PO#2602--FOUNTAIN--Gate style #20----- thickness: 2-1/4"

PROWELL Woodworks
800.466.1850

Dated: Feb 2, 2026

Carefully review this drawing and noted specifications for your made-to-order product. Final approval is required before production can begin, at which point no returns or refunds will be granted. You will receive an e-signature link to transmit your final approval.

GATE #1
Exterior Front Left Gate

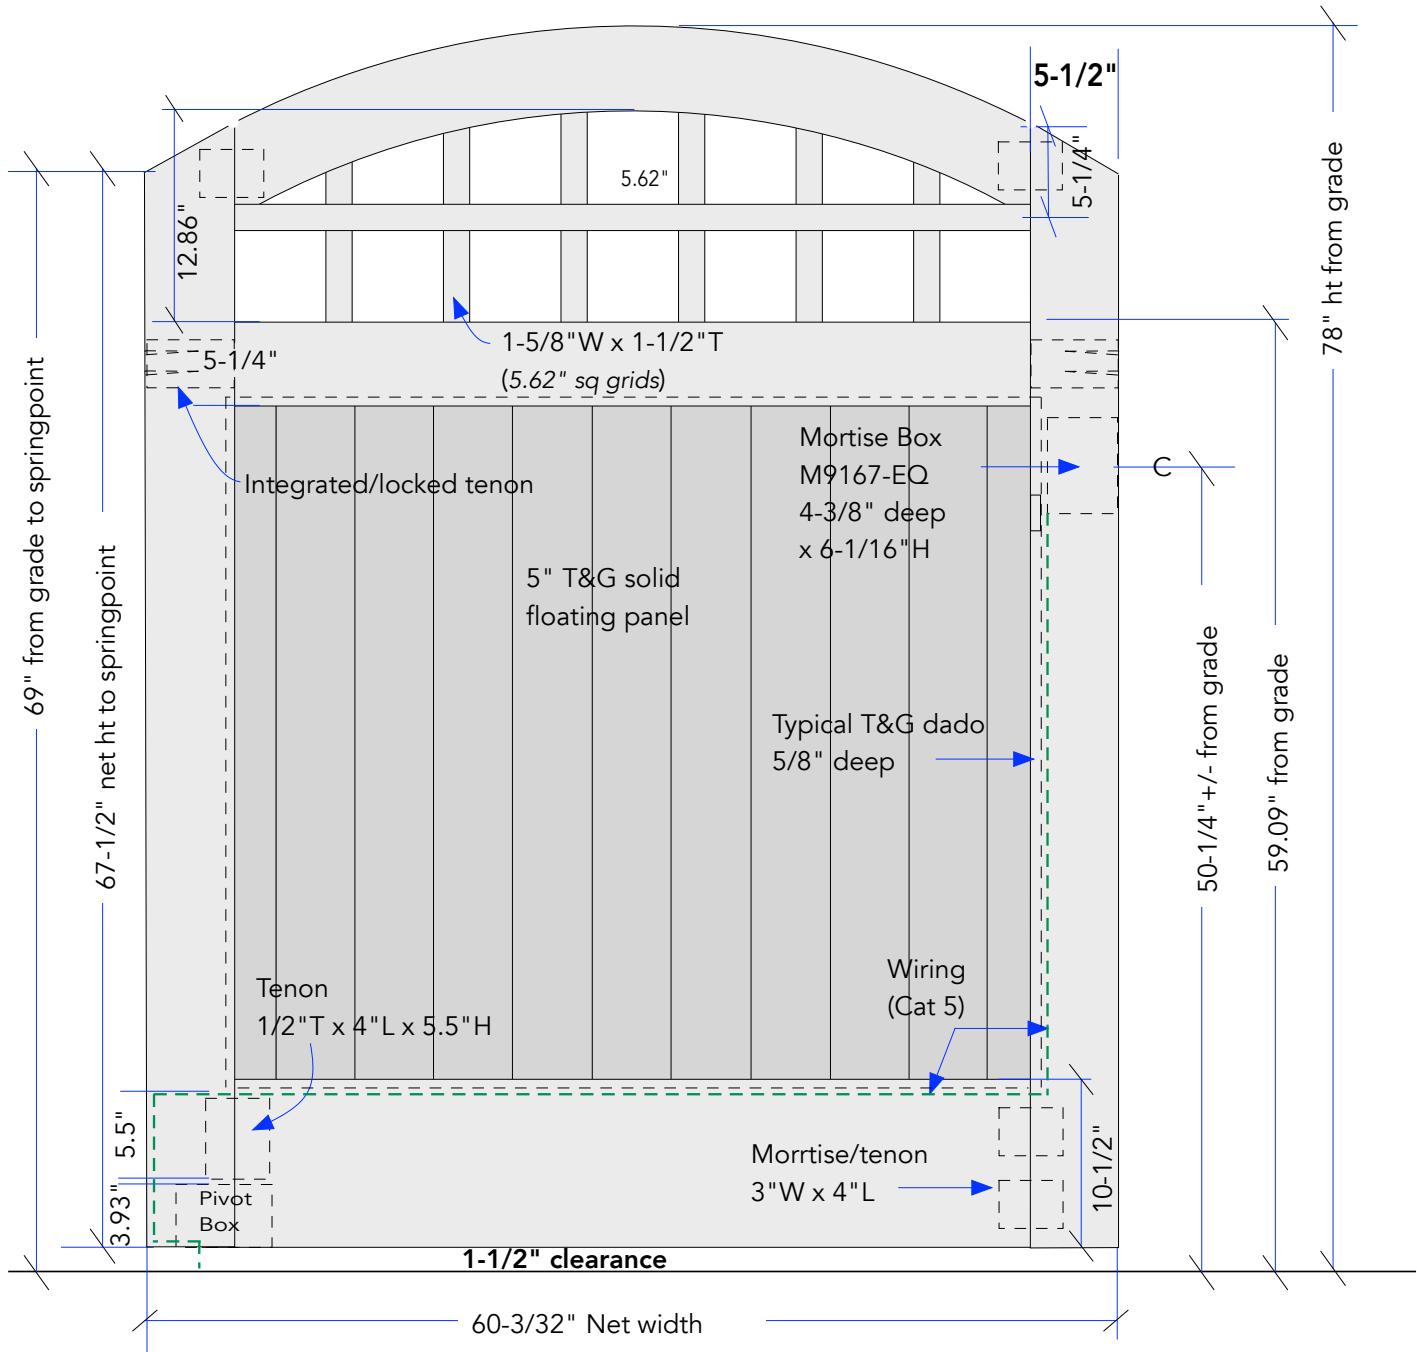
Feb 1 revisions:

- *Add two grid columns. from 8.51" to 5.62" grids
- *59.09" from grade to top of mid-rail
- *Raised the mortise lock below the mid-rail tenon
- *10-1/2"W bottom rail

GATE #2
Exterior Front Right Main Gate

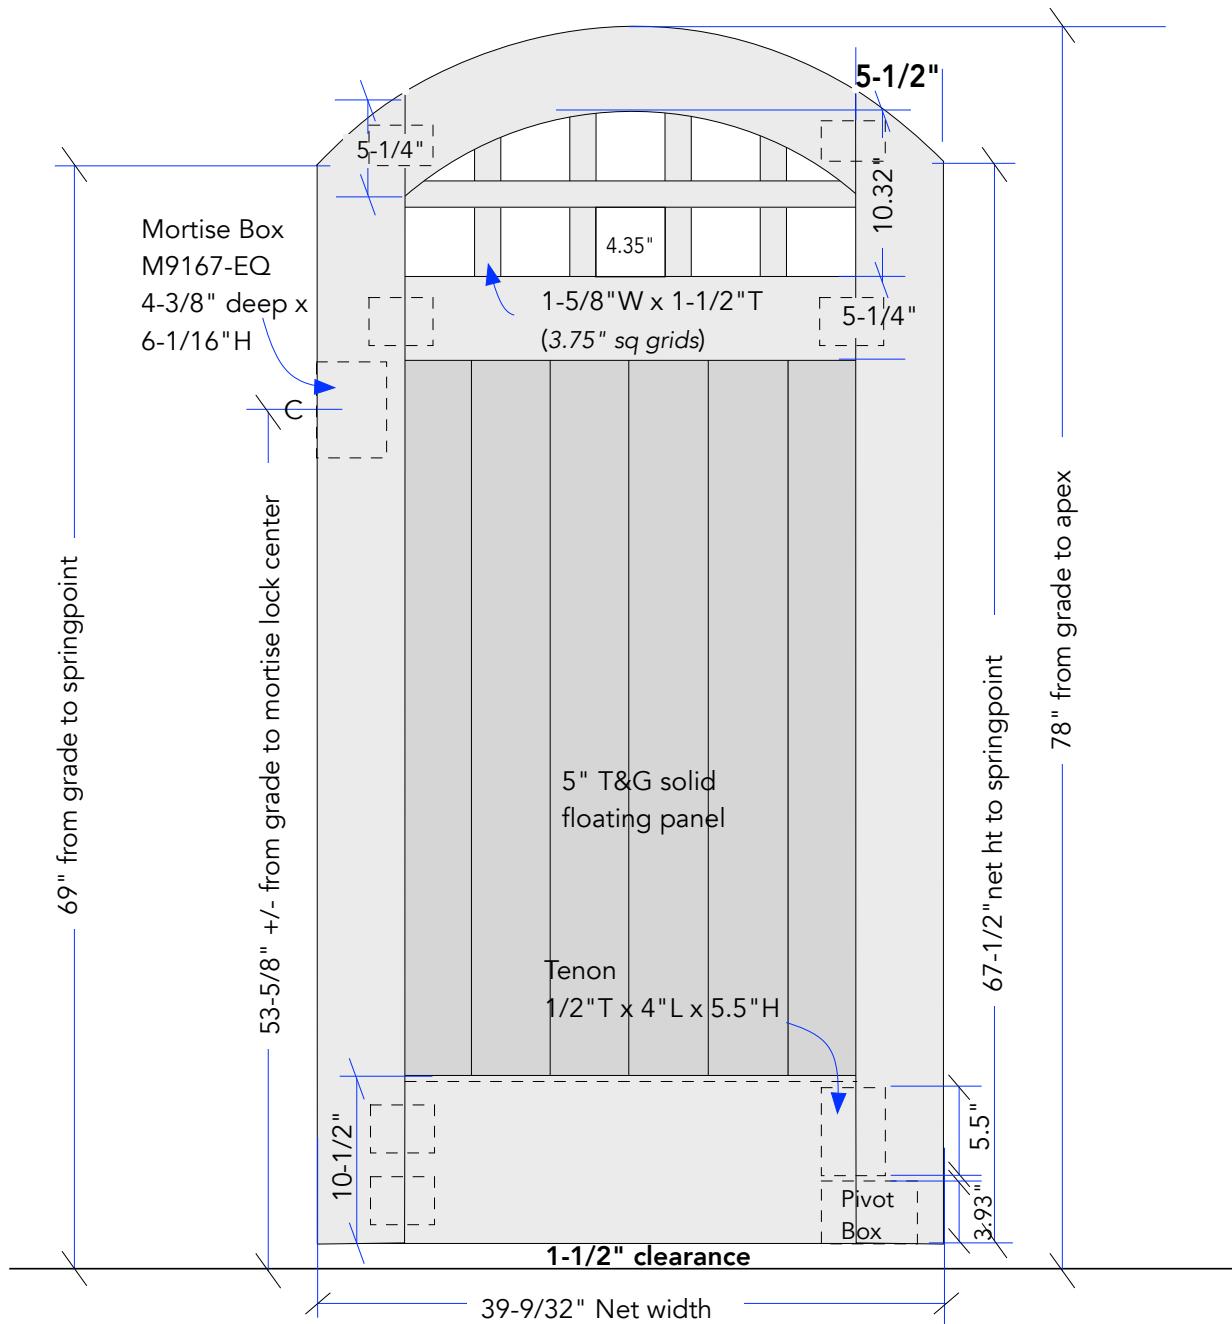
Revisions:

- * Mortise lock below the mid-rail
- * 10-1/2" bottom rail

GATE #3

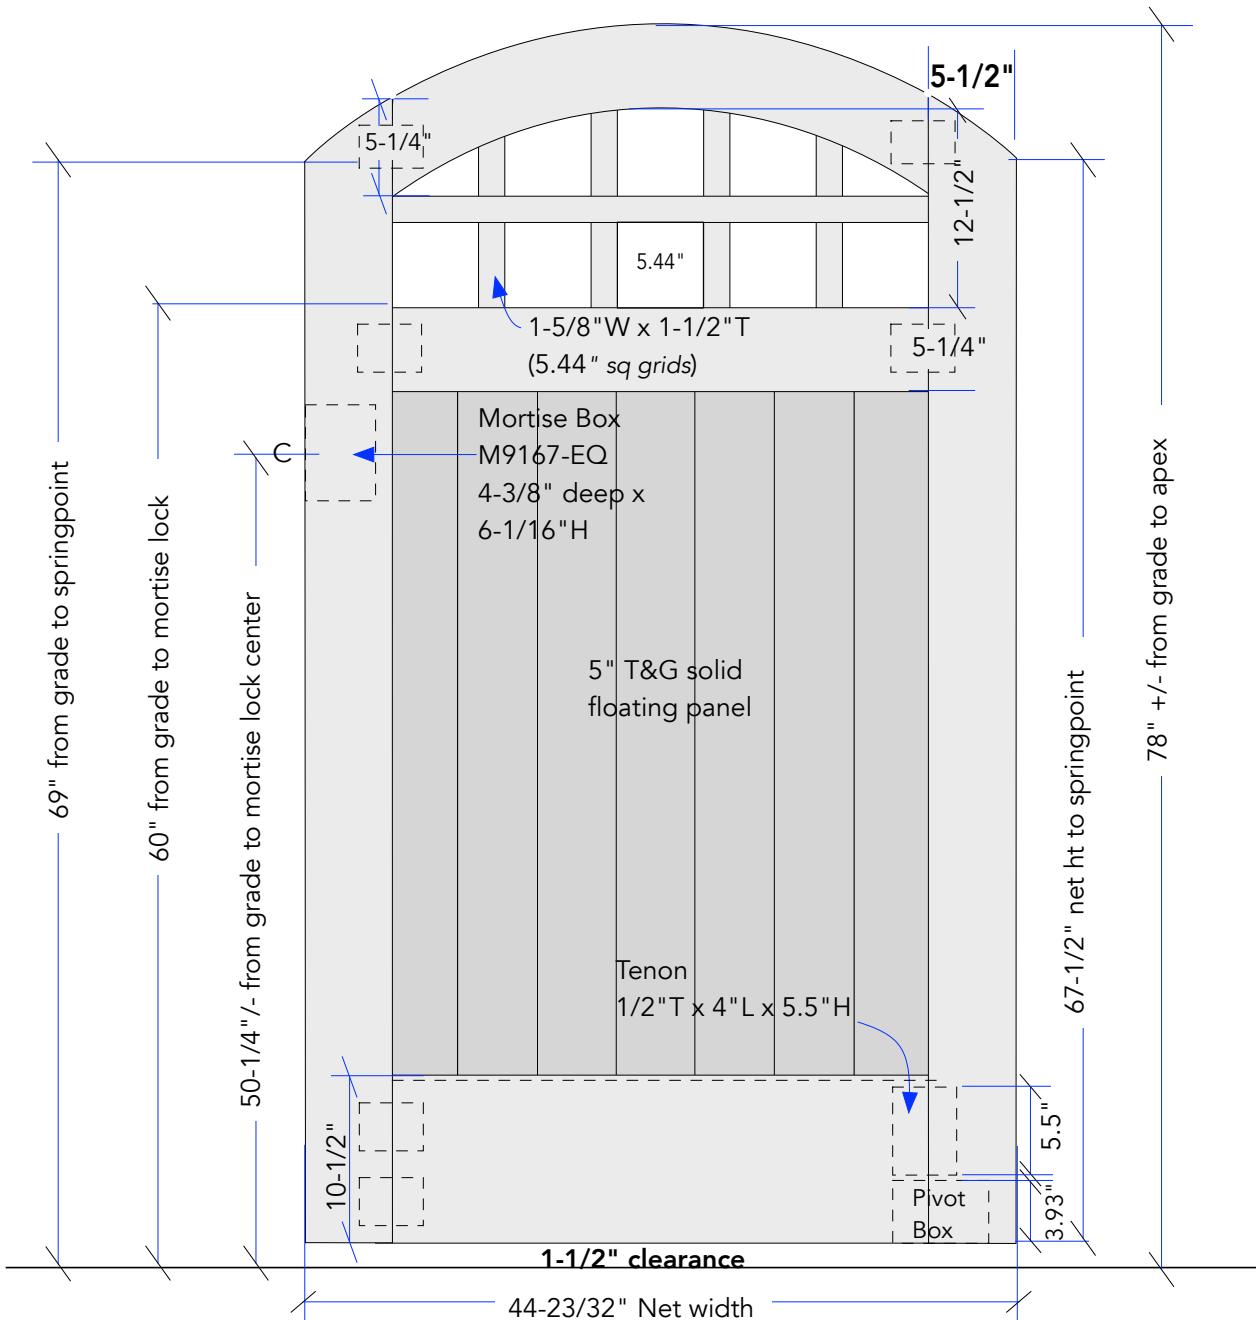
Revisions:

*Mortise lock below the mid-rail

* 10-1/2" W bottom rail

GATE #4

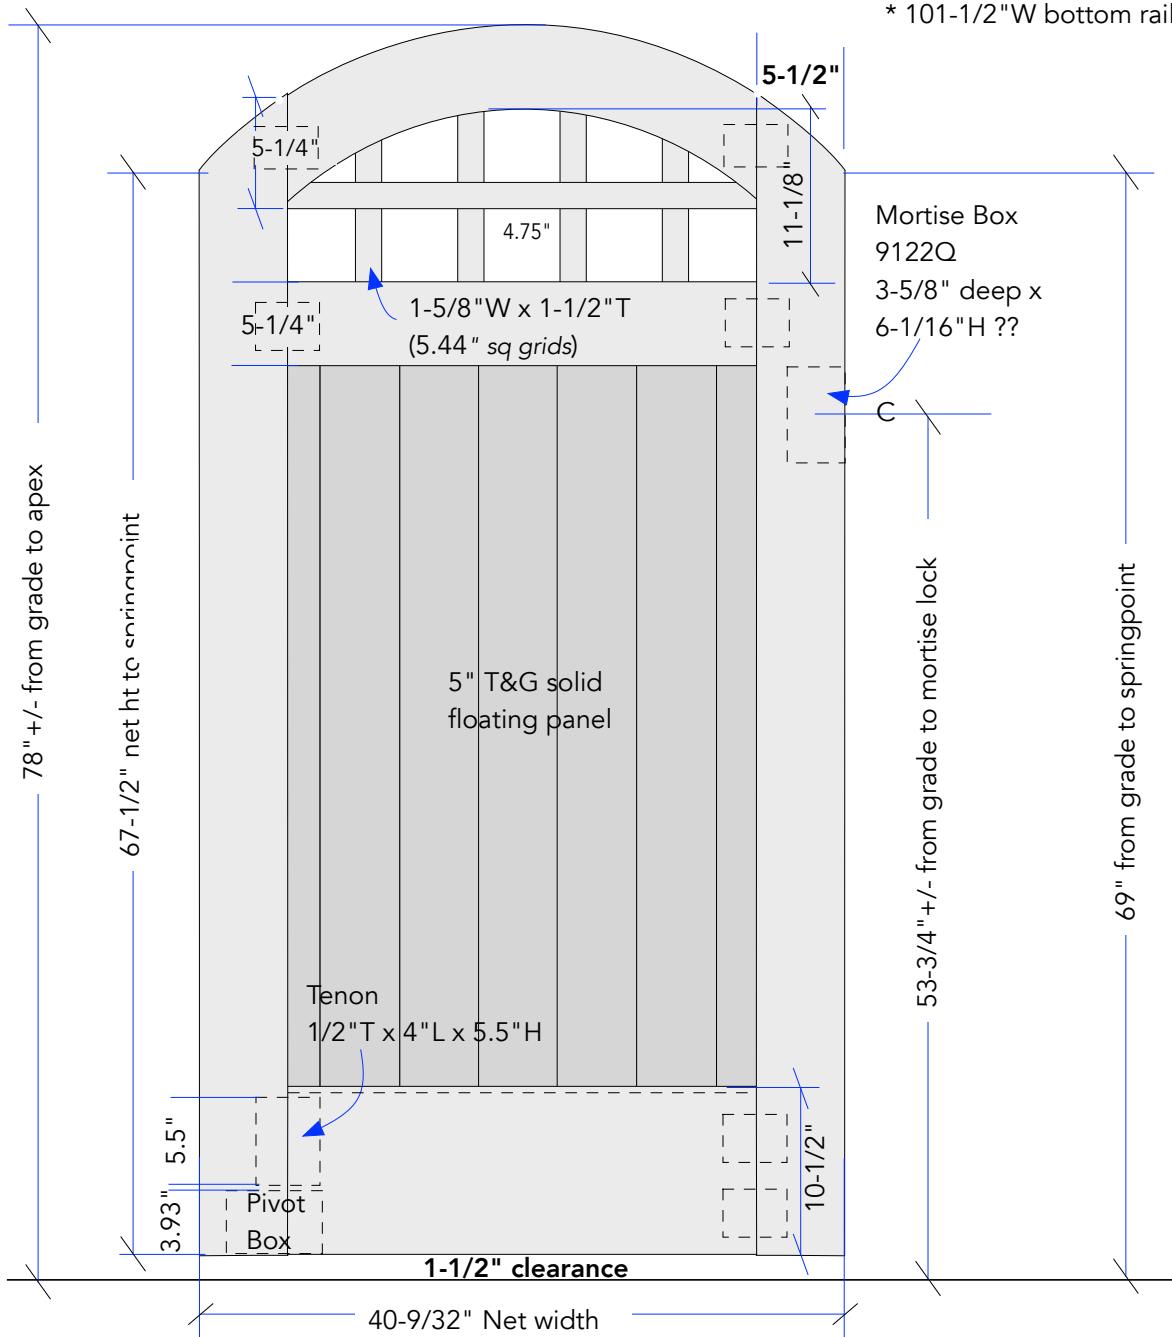
Revisions:

*Mortise Lock below the mid-rail

* 101-1/2"W bottom rail

GATE #5
Pool House Shower Gate
2.02" SQ GRIDS---LH-IN SWING
Radius 26.91

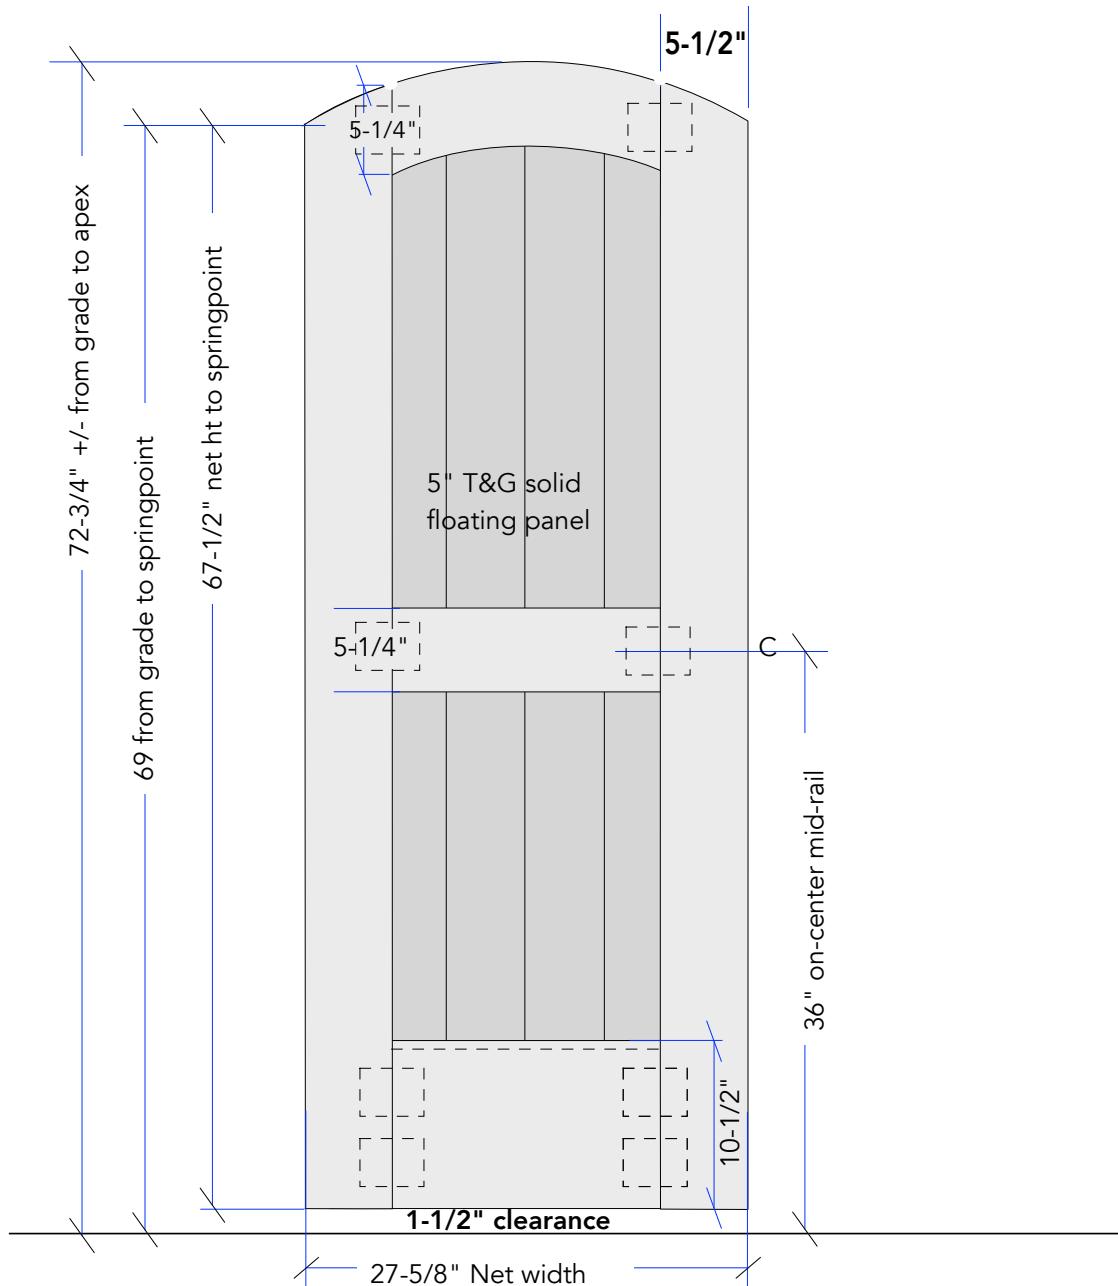
Jan 6 revisions:
* Mortise Box above the mid-rail
* 10-1/2" W bottom rail

GATE #6
Creek Rear Gate

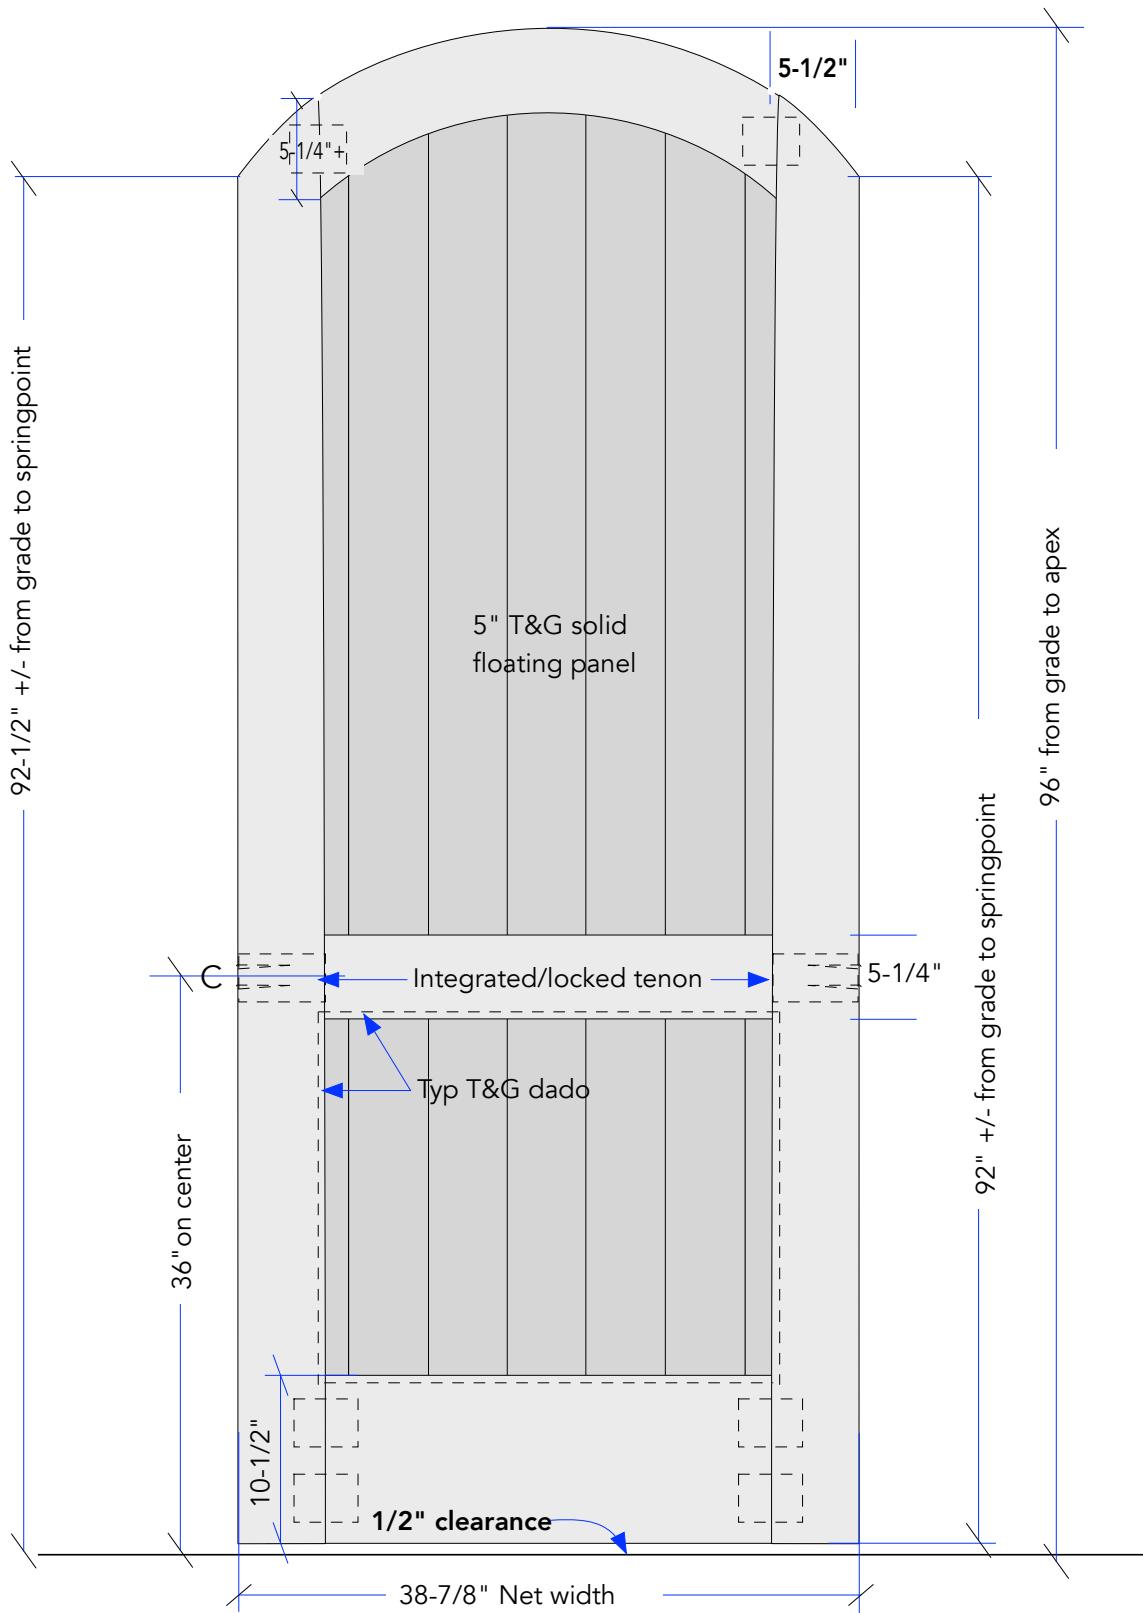
revisions:

- * Mid-rail at 36" O.C. with integrated tenons.
- * 1-1/2"W bottom rail
